**Queenstown Lakes District Council**

**Section 42A Hearing Report**

**REPLY**

**following the hearing on the Te Pūtahi Ladies  
Mile proposed plan variation request,  
submissions and further submissions.**

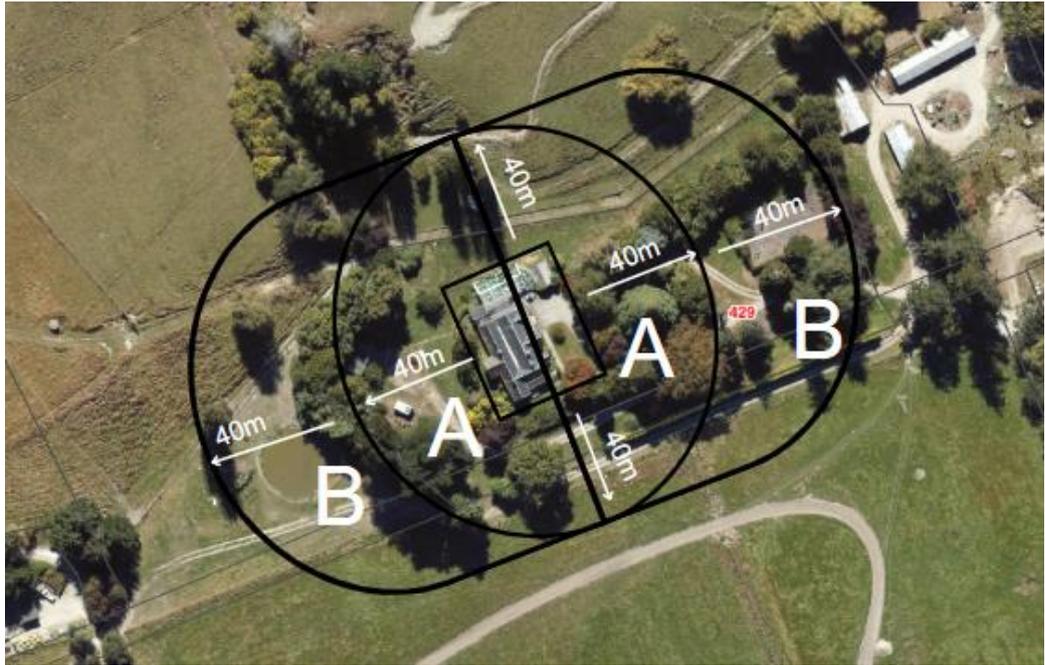
14.7 Mr Miller in his Reply Statement recommends slightly different relief to Mr Murray, as follows:

- a 40m setback around the homestead (no buildings);
- a building height limit of 8m within a wider setback area (80m to the east of the homestead and 100m to the west) (and maintaining a depth of 40m to the north and 40m south of the homestead);
- a 17m height limit in the Glenpanel Precinct outside of this larger setback area.

14.8 I have set these setback areas out on an aerial, as follows:

- 14.9 Note that the Homestead grounds do not extend directly east and west from the edges of the Homestead but more northeast and southwest, and the above illustration recognises this orientation.

- 14.10 I broadly agree with Mr Miller's approach, for the reasons he sets out in his Reply Statement, noting also the protection afforded to the Glenpanel area (not just the homestead) under Chapter 26 of the PDP (Historic Heritage) which applies a Category 3 listing and RDA consent is required for development<sup>40</sup> within the setting. I question whether the additional 60m to the southwest is too far, however, and whether this could be trimmed back to 40m, in the interests of not unreasonably disabling development in this area. My preference is for a further 40m, not 60m.

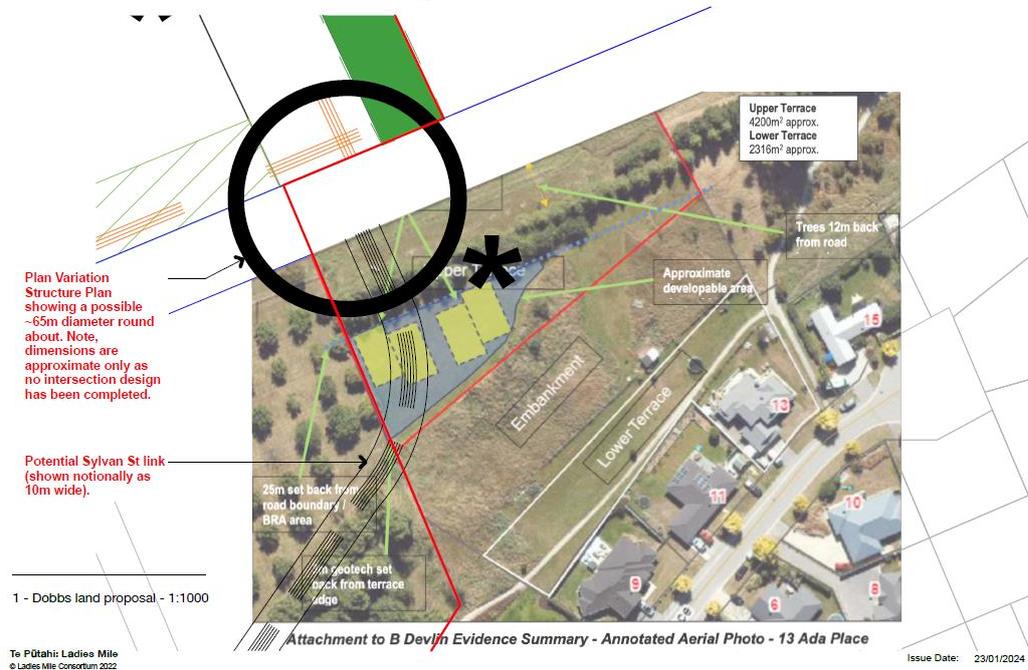
17.2 I reiterate the point made in the s42A Report<sup>46</sup> and in the Rebuttal statement<sup>47</sup> that the upper terrace of the Dobb property, adjacent to SH6, will in all likelihood be required for the SH6 eastern intersection (a roundabout).
